Title - Sujet ONE(1) BLUE BIRD VISION SCHOOL BUS	
Solicitation No. - N° de l'invitation T8009-200299/A	Amendment No. - N° modif. 001
Client Reference No. - N° de référence du client T8009-200299	Date 2021-03-22
GETS Reference No. - N° de référence de SEAG PW-\$\$HP-927-79811	
File No. - N° de dossier hp927.T8009-200299	CCC No./N° CCC - FMS No./N° VME
Solicitation Closes - L'invitation prend fin at - à 02:00 PM Eastern Daylight Saving Time EDT on - le 2021-04-16 Heure Avancée de l'Est HAE	
F.O.B. - F.A.B. Plant-Usine: <input type="checkbox"/> Destination: <input type="checkbox"/> Other-Autre: <input type="checkbox"/>	
Address Enquiries to: - Adresser toutes questions à: Takam(hp927), Maurice	Buyer Id - Id de l'acheteur hp927
Telephone No. - N° de téléphone (613) 297-3516 ()	FAX No. - N° de FAX () -
Destination - of Goods, Services, and Construction: Destination - des biens, services et construction:

AMENDMENT 001

This Solicitation Amendment 001 is raised to answer bidders' questions and amend Annex "B" – Statement of Work

ANNEX "B" - STATEMENT OF WORK BLUE BIRD VISION SCHOOL BUS (Revised)

IMAGE 1

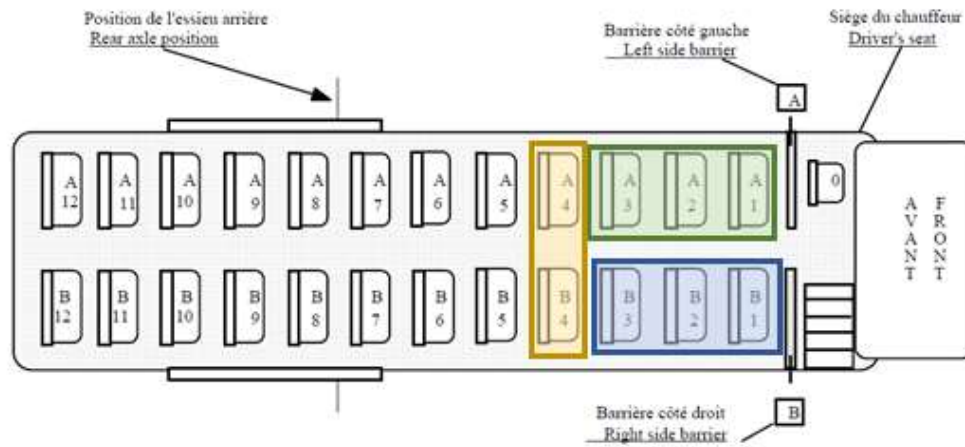
1.8	• Transmission: Automatic or Automated as available		
1.9	• Must be equipped with Electronic Stability Control (ESC)		
1.10	• Standard Barriers in position A and B (behind driver and behind staircase - See Image 1)

1.11	• Vehicle interior – Seat Configuration (See Table 1, Image 1 and 2)		
	○ Minimum of 70 passengers		
	○ Bench A1 to A3 with 3 three point belt per bench (first three row behind driver)		
	○ Bench B1 to B3 with 3 three point belt per bench (three first row on passenger side)		
	○ Bench A4 and B4 with 2 Integrated Child Restraint Systems (2 per bench) (See image 2)		
	○ Bench A5 to A12 and B5 to B12 with standard bench
